HISTORIC AND DESIGN REVIEW COMMISSION

August 16, 2017

HDRC CASE NO: 2017-365
ADDRESS: 1126 N ST MARYS
LEGAL DESCRIPTION: NCB 819 BLK 30 LOT N IRR 200 FT OF A2 NCB 834 BLK 19 LOT S
ZONING: TRI 156.35 OF N 205 OF A1
CITY COUNCIL DIST.: FBZ T6-2 RIO-2
APPLICANT: 1
OWNER: Benito Polendo
TYPE OF WORK: Luis Kernion
REQUEST: Exterior modifications, landscaping and hardscaping modifications

The applicant is requesting conceptual approval to rehabilitate the structure located at 1126 N St Marys. The scope of work will include:

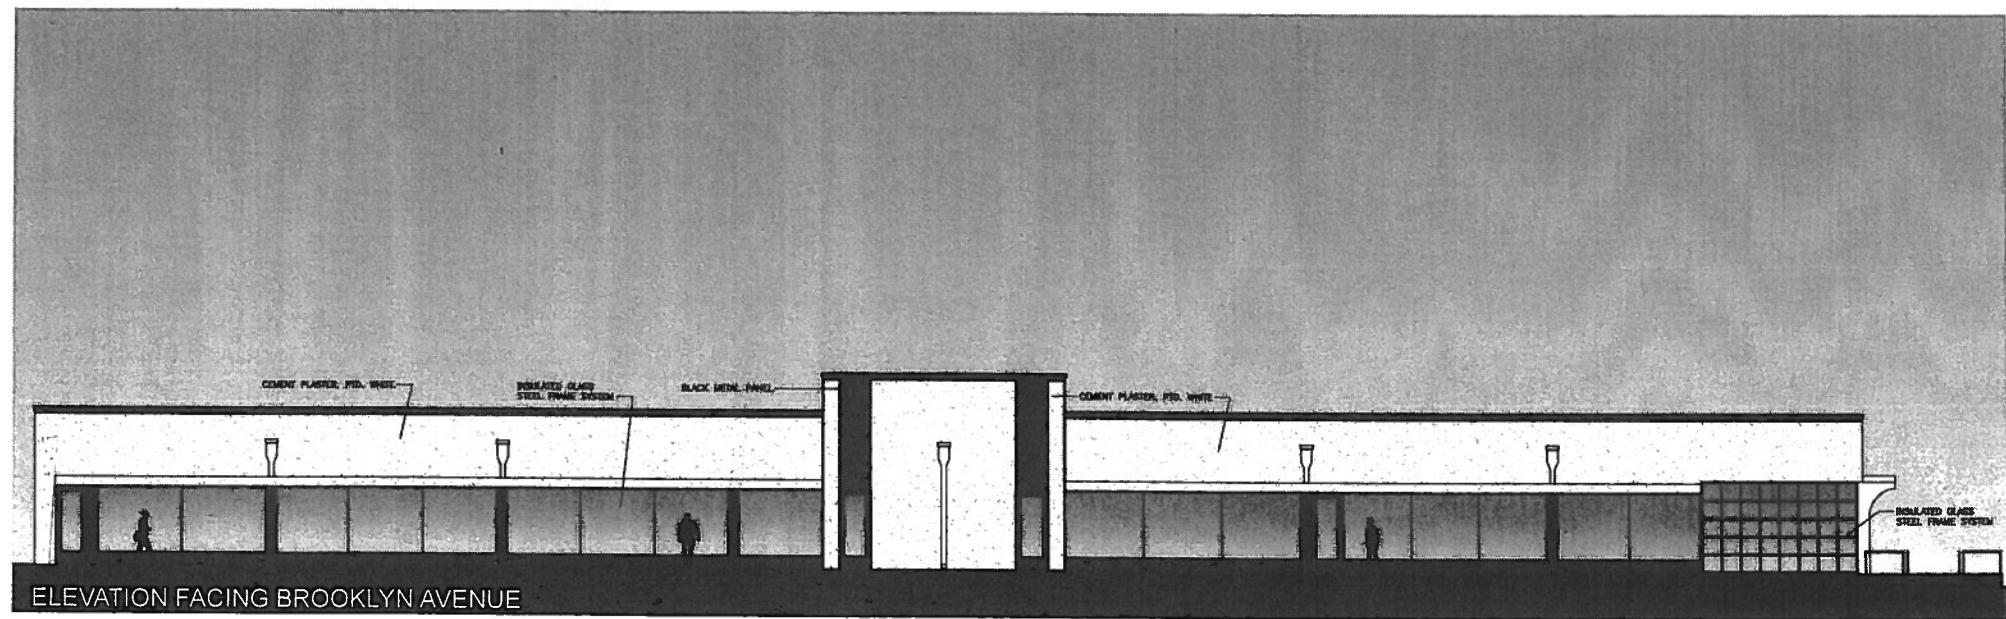
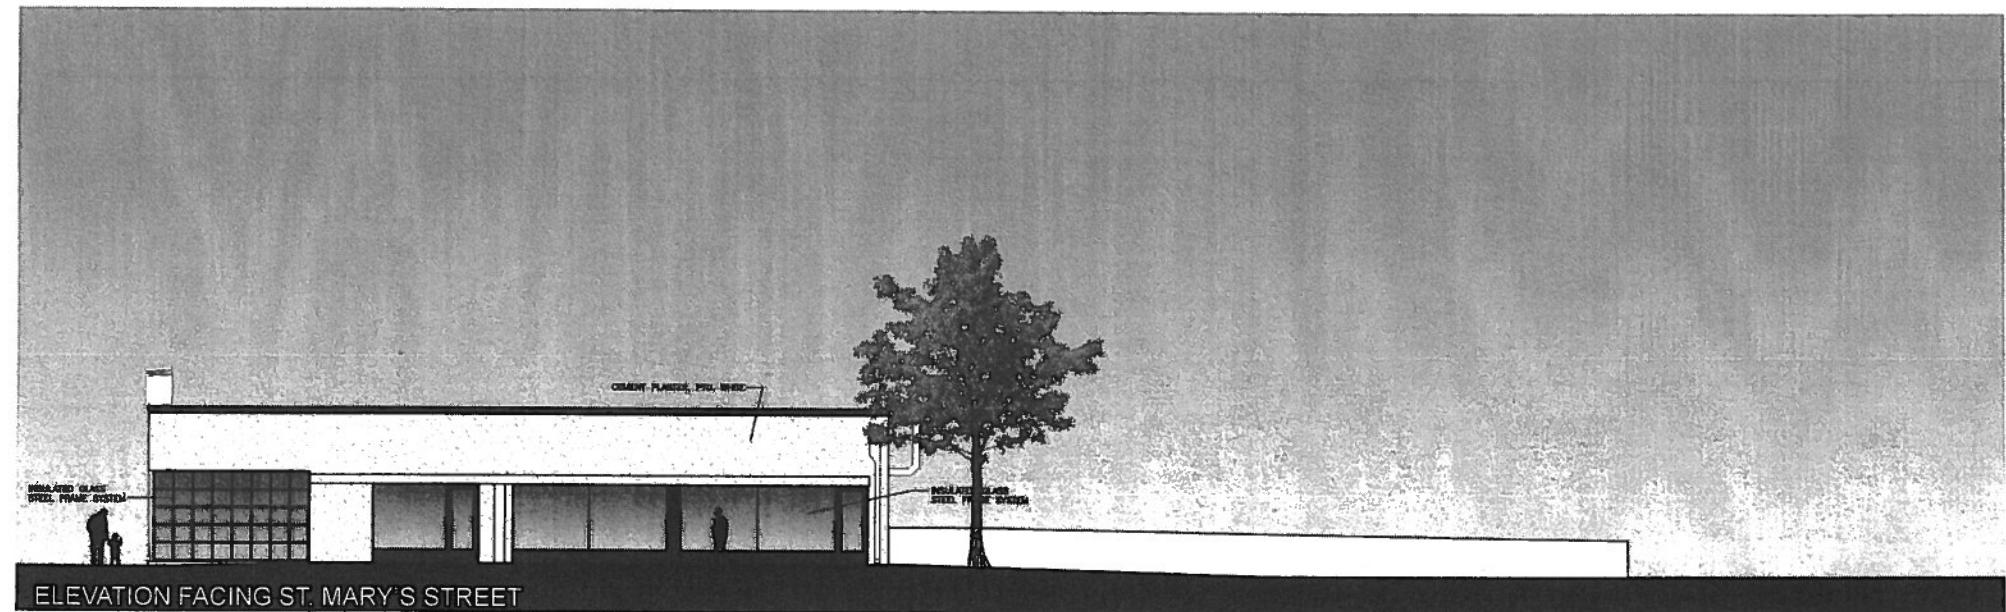
- c. **WINDOW MODIFICATIONS** – The applicant has proposed to remove the existing windows and replace with a new insulated glass and divided lite steel frames on the two primary elevations facing N St Marys and Brooklyn Ave. The existing windows are a mix of aluminum storefront windows on the N St Marys elevation and steel frame divided lites on the Brooklyn Ave elevation. The applicant received administrative approval to begin replacing windows in-kind to match the existing in dimensions, materials, and design. The current proposal will alter the materiality of the windows on the N St Marys elevation and alter the openings on both N St Marys and Brooklyn Ave. While the installation of this new storefront system will alter the existing opening, staff finds that the main design intent of the existing original structure will largely remain intact. This is consistent with the UDC Section 35-676(i).

- d. **PARAPET** – The applicant has proposed to add height to the existing parapet to conceal new mechanical equipment from the public right-of-way. The proposal will add approximately 3 feet to the existing height. This will be achieved with a lightweight structure and will be covered in a stucco finish to match the existing facade texture. A detail at the top of the parapet, either painted or tiled, is proposed. Staff finds the approach consistent with the UDC.

element on the exterior of the existing structure, located in the center of the elevation facing Brooklyn Ave. The elements appear to measure approximately 5 feet taller than the existing flat roofline, though no dimensioned drawings have yet been provided. The applicant's proposals are generally consistent with the UDC Section 35-674(d)(1) and (2) in terms of massing and location, though final material specifications have not yet been provided.

Staff recommends conceptual approval based on findings a through j. The applicant should consider the following when working towards final approval:

1. That the applicant confirms all design decisions, including architectural details, materials, and other specifications as noted in the findings.
2. That the applicant indicates all hardscaping and landscaping modifications or additions as noted in findings e and f. The documentation should include a full site section that indicates how the proposed walkway will affect the existing parking lot's slope, along with information on the proposed staircases and any ADA requirements.
3. That the applicant submits a comprehensive, multi-tenant signage plan as noted in finding j.

1126 N. ST. MARY'S PROJECT - FLOOR PLAN

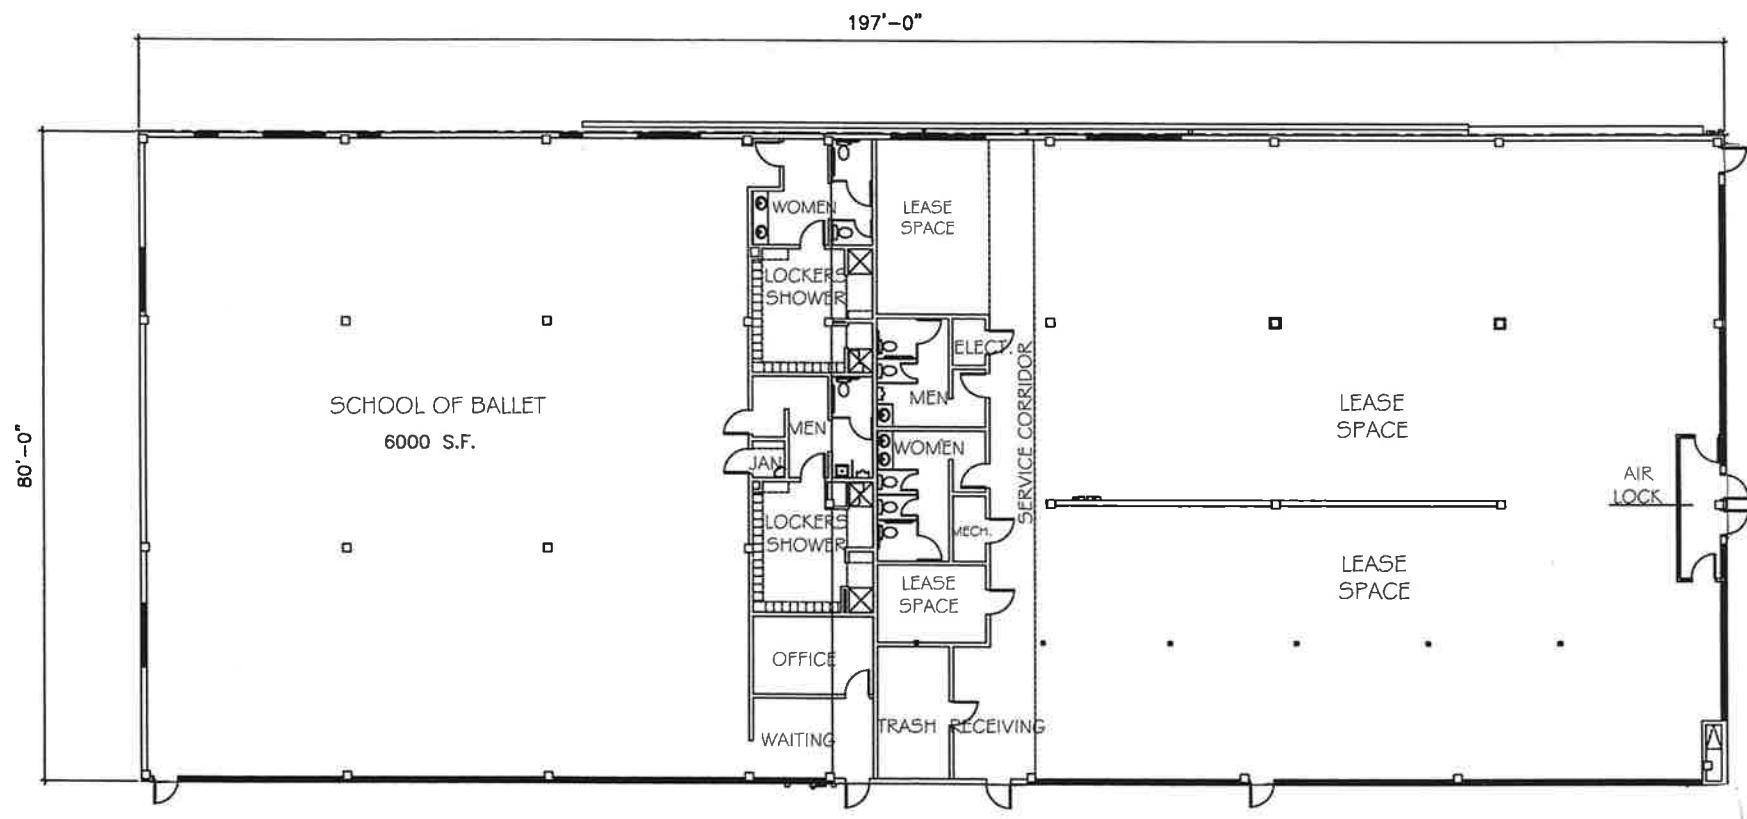
- i. **PARKING LOT MODIFICATIONS** – On the east façade, the applicant has proposed to install a new door to be identical to the easternmost door of the south façade and a new storefront system to provide access from the proposed parking area into the structure. This is consistent with the UDC Section 35-676(i).

- k. **SIGNAGE** – The applicant has verbally indicated that the new architectural elements will potentially feature signage. The floor plan also indicates that the building will be multitenant in the future, which has been confirmed by the applicant. The applicant is required to provide a comprehensive signage plan for final approval.
